<b>Delegated Report</b>		<b>Analysis sheet</b>		<b>Expiry Date:</b>		10/07/2014	
		N/A		<b>Consultation Expiry Date:</b>		19/06/2014	
<b>Officer</b>				<b>Application Number(s)</b>			
Alex McDougall				2014/3435/P			
<b>Application Address</b>				<b>Drawing Numbers</b>			
68A Delancey Street London NW1 7RY				Refer to draft decision notice.			
<b>PO 3/4</b>		<b>Area Team Signature</b>		<b>C&amp;UD</b>		<b>Authorised Officer Signature</b>	
<b>Proposal(s)</b>							
Erection of roof terrace, with associated balustrades, planters and access staircase from existing roof terrace, and alterations to existing fenestration.							
<b>Recommendation(s):</b>		Grant planning permission					
<b>Application Type:</b>		Full Planning Permission					
<b>Conditions or Reasons for Refusal:</b>		Refer to Draft Decision Notice					
<b>Informatives:</b>							
<b>Consultations</b>							
<b>Adjoining Occupiers:</b>		No. notified	<b>44</b>	No. of responses No. electronic	<b>09</b> <b>08</b>	No. of objections	<b>09</b>

### Site Description

**Figure 1. Sightline from proposed roof terrace to rear of Albert Street properties.**

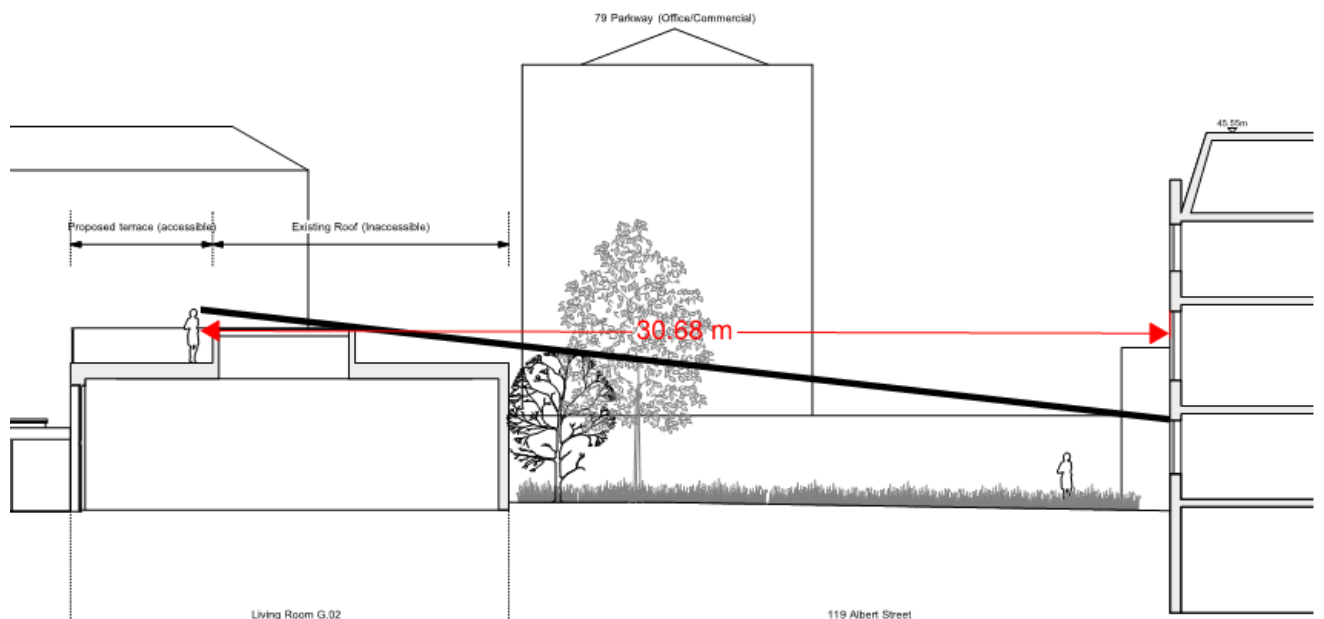
- a) The adjoining Albert Street properties to the north east are already overlooked by an

existing roof terrace at second floor level which is higher and closer than the proposed terrace.

- b) The diagram below demonstrates that an average person standing on the terrace would not have a line of site to the rear garden of the adjoining properties or the ground floor rear windows.

- c) Camden Planning Guidance 6 (Amenity) states that an 18m separation is generally considered to be sufficient to retain privacy between two areas. The nearest section of the proposed terrace is over 30m from the rear windows of the Albert Street properties. As such the proposed separation is well in excess of that required.

- d) The proposal includes two planters to either side of the terrace which are considered to be sufficient to restrict access to the rest of the roof. Notwithstanding, a condition will be included requiring that these planters be installed prior to use of the terrace, retained thereafter and that the remainder of the roof not be used as a terrace.
